# 1955 PITTWATER ROAD, BAYVIEW

S4.55 AMENDED PLANS

DRAWING LIST

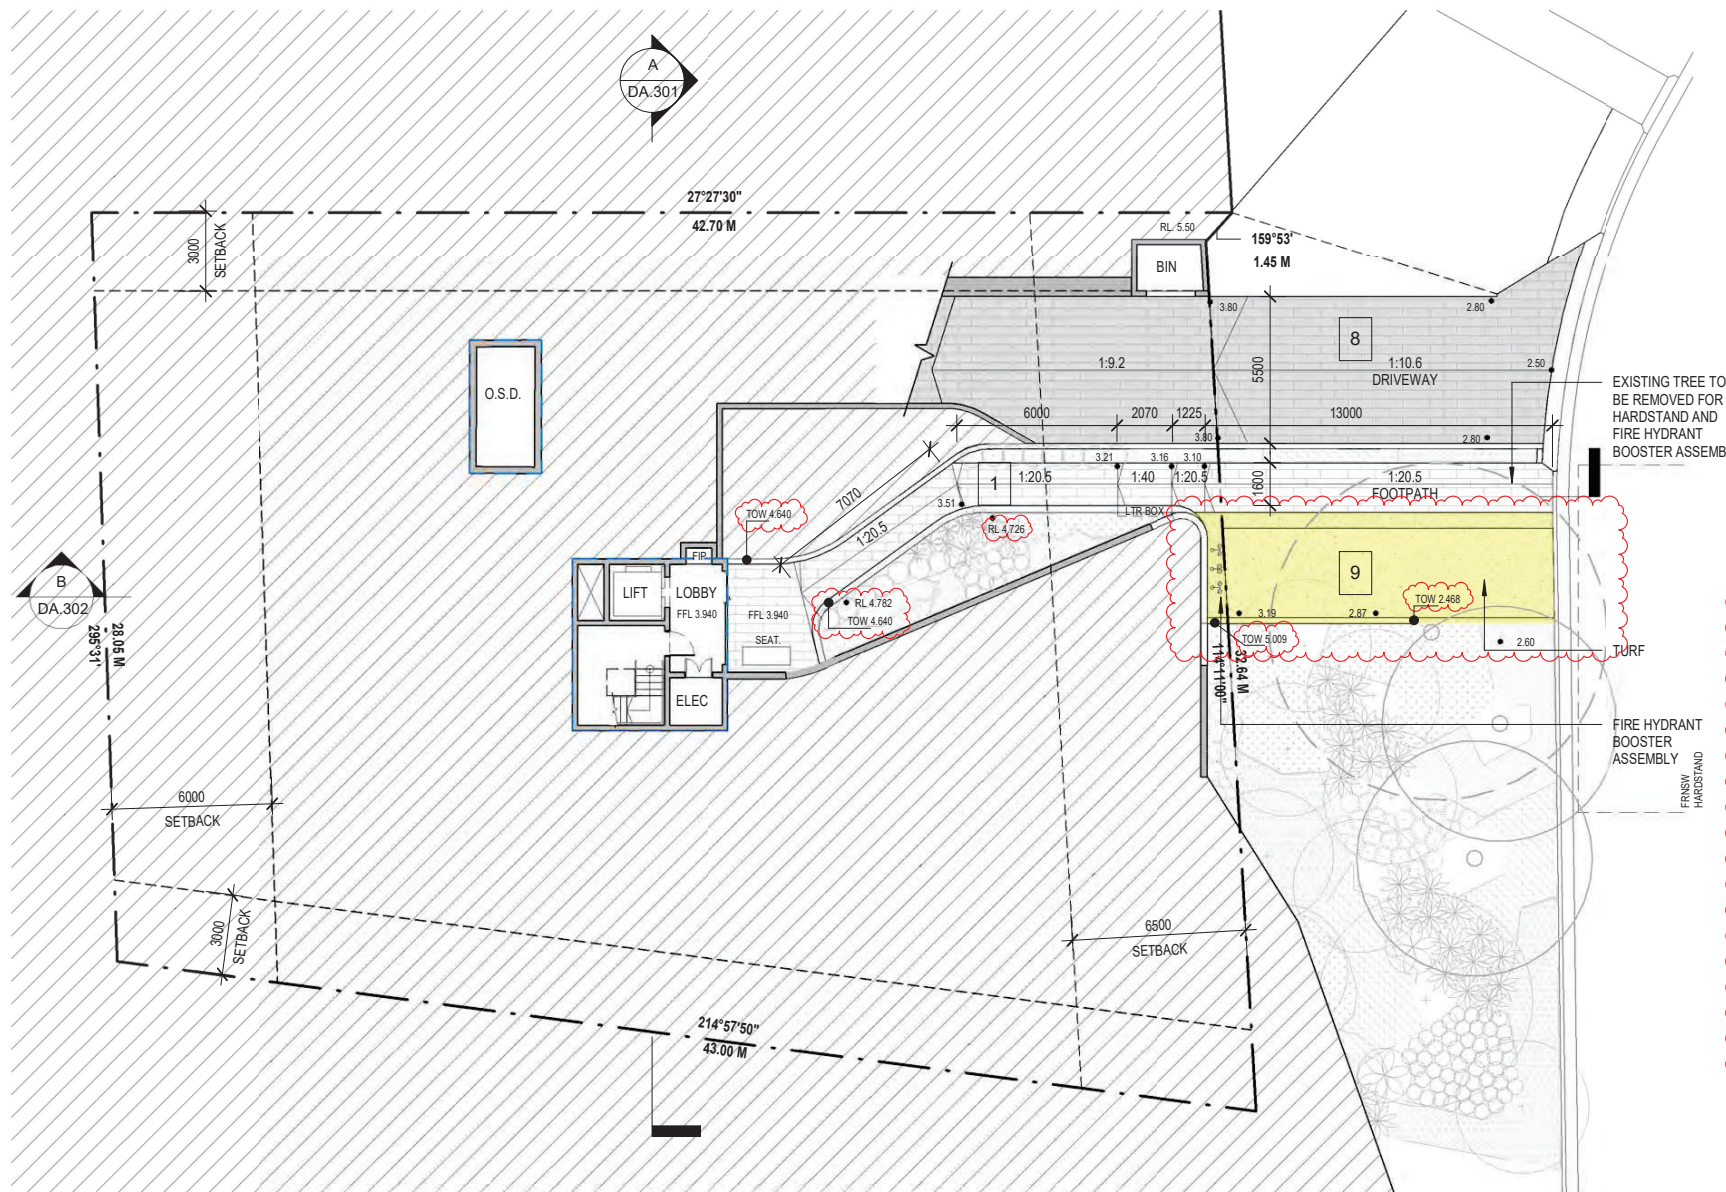
- 1. Entry Pedestrian Ramp** - Increased pedestrian ramp width to 1600mm for accessibility
- 2. Building Entry** - New awning and vertical louvre screen to increase sense of entry.

- 3. Balcony Articulation** - New curved balconies for improved aesthetics. Increase in outdoor private open space area and solar access for improved amenity

- 4. Fencing** - New fencing to provide safety and security
- 5. Roof** - New rooftop plant enclosure to comply with services requirements
- 6. First Floor Roof Deck/ Landscaping** - Change in configuration of First Floor roof deck to integrate with overall building aesthetics. New landscape buffer around perimeter of First Floor roof deck for improved privacy and softening of built form

- 7. Roof & Floor RL** - Adjustment in floor-to-floor heights to reflect structural and building services requirements.
- 8. Vehicular Access** - Design development to comply with accessibility & Australian Standards.

- 9. FRNSW Requirement** - to provide handstand & fire hydrant booster assembly, requiring removal of tree T3 (Refer to Arborist Report).
- 10. Carpark Floor Plan** - Parking re-configuration within approved footprint.

- 11. Lower Ground Floor Plan** - Increase in Unit 4 storage area to accentuate recess and alignment between the two modulated built forms. Louvred door and panels for maintenance and ventilation. New landscaped terrace to integrate with cascading balconies above and overall building aesthetics.

- 12. Unit layouts** - Internal reconfiguration and increase in unit size for improved amenity.
- 13. Elevations** - Removal of wall break in east elevation of Units 3 and 4. Revised façade and window treatments associated with plan amendments

- 14. Boundary Fence** - 1.8m high painted fencing capped and lapped in Dulux 'Winter Fog'
- 15. Vertical Screening** - Continuation of vertical screening over lift shaft to accentuate recess between the two modulated built forms

- 16. Proposed Terrace Extension**

**DA2021/0343 APPROVED  
(28 TREES)**

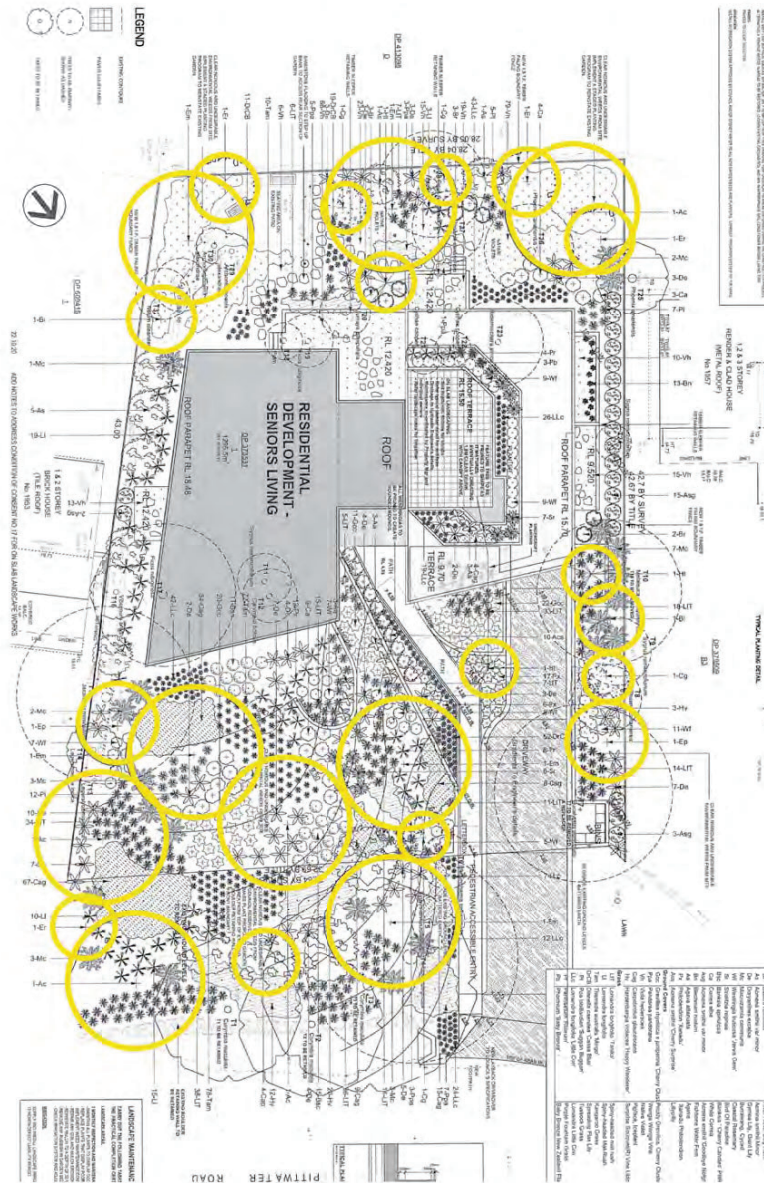
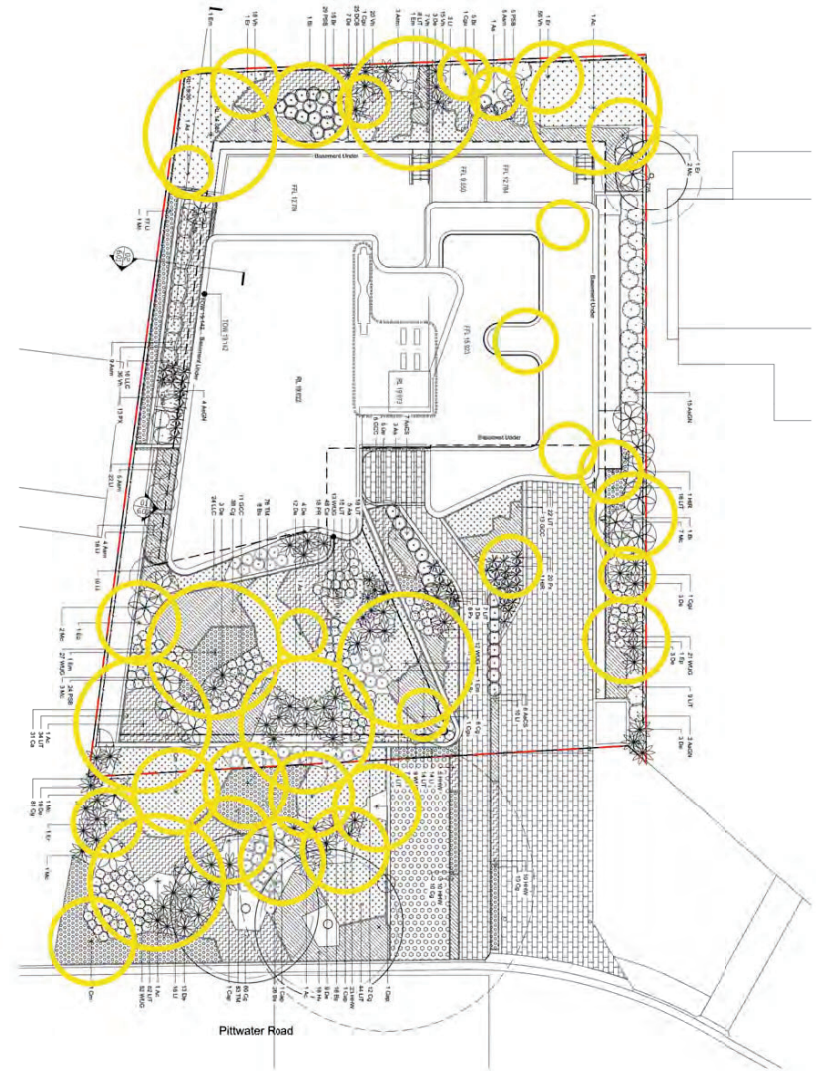
**CURRENT PROPOSAL  
(35 TREES)**
